# Access Compliance Report Public Rights-of-Way (Curb Ramps)

**Main Street:** MAGNOLIA\_AVE      **Cross Street:** MAGNOLIA\_AVE      **Location:** W

**ADA ID:** RPRK210921155934      **Ramp Type:** Type 4 - Parallel      **Initial Pass/Fail:** Fail      **Overall Compliance:** No      **Severity Score:** 2

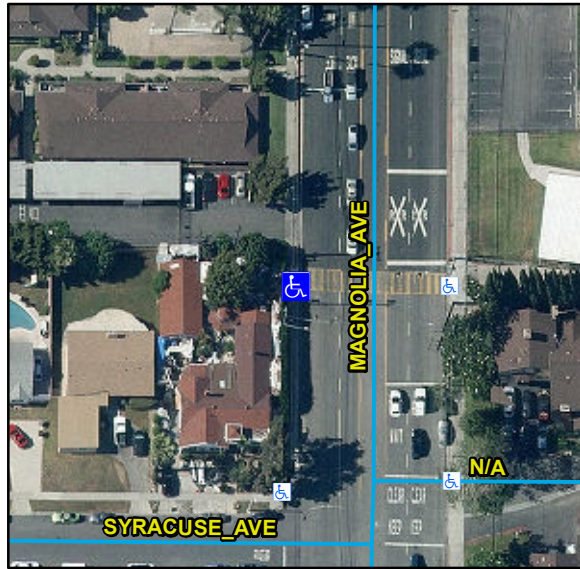
Compliance	Description	Data	Compliance	Description	Data
N/A	Ramp Length LT (in)	87	N/A	Ramp Length RT (in)	88
Yes	Ramp Width LT (in)	88	Yes	Ramp Width RT (in)	86
Yes	Ramp Run Slope LT (%)	5.9	Yes	Ramp Run Slope RT (%)	5.9
Yes	Ramp Cross Slope LT (%)	0.9	No	Ramp Cross Slope RT (%)	2.8
N/A	Landing Present	N/A	N/A	DWS Provided	N/A
N/A	Landing Length (in)	N/A	N/A	DWS Contrast	N/A
N/A	Landing Width (in)	N/A	N/A	DWS Length (in)	N/A
N/A	Landing Run Slope (%)	N/A	N/A	DWS Full Width	N/A
N/A	Landing Cross Slope (%)	N/A		DWS Offset Type	N/A
N/A	Landing Movement Obstructed?	N/A	N/A	DWS Offset Left (in)	N/A
	Landing Movement Type	N/A	N/A	DWS Offset Right (in)	N/A
N/A	Landing Shared	N/A			
N/A	Clear Space	N/A			
N/A	Clear Space To Crosswalk (in)	N/A			
N/A	Marked Crosswalk 1	Yes	N/A	Marked Crosswalk 2	N/A
	Crossing 1 Direction	E		Crossing 2 Direction	N/A
N/A	Marked Crosswalk 1 Width (in)	140		Marked Crosswalk 2 Width (in)	N/A

**Possible Solutions:**  
**Remove & Replace Entire Ramp.**

**OC Std/PROW:**  
 R304.5.3, STD 1115
